NEVADA DEPARTMENT OF TRANSPORTATION
SUPPLEMENTAL NOTICE TO CONTRACTORS NO. 6
Contract 3983

Reference is made to Project NHP-0191(104), on US 395, North of Reno, from McCarran to Golden Valley Structure, in Washoe County, upon which bids will be received until 2:00 p.m., PDT, on the 13th day of July 2023, and opened publicly on that date at the above hour.

Prospective bidders are hereby directed to remove and destroy plan sheets 3G, 3H, SD7, LS104, and LS105 and replace them with the attached same numbered sheets dated 06/28/2023. Following is a brief explanation of the changes:

**SPECIAL DETAILS
 MEDIAN OFFSET
 BARRIER WALL**

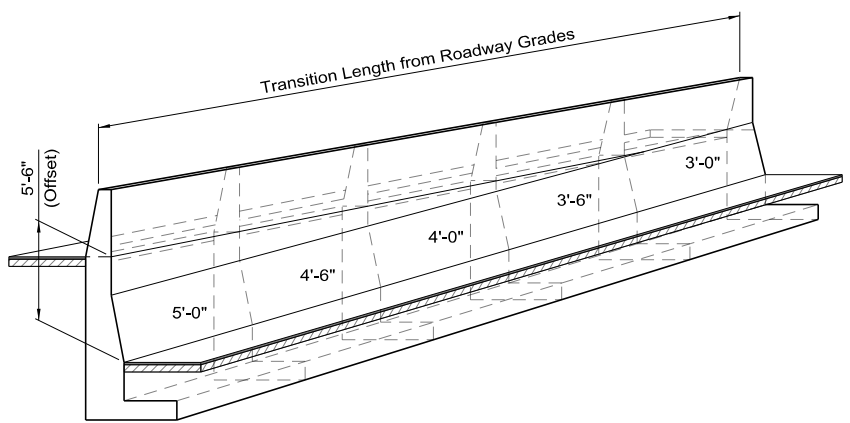
Sheet SD7. Note Deleted.

REV. 1 6/28/23 TWK
 NOTE 8 REMOVED.
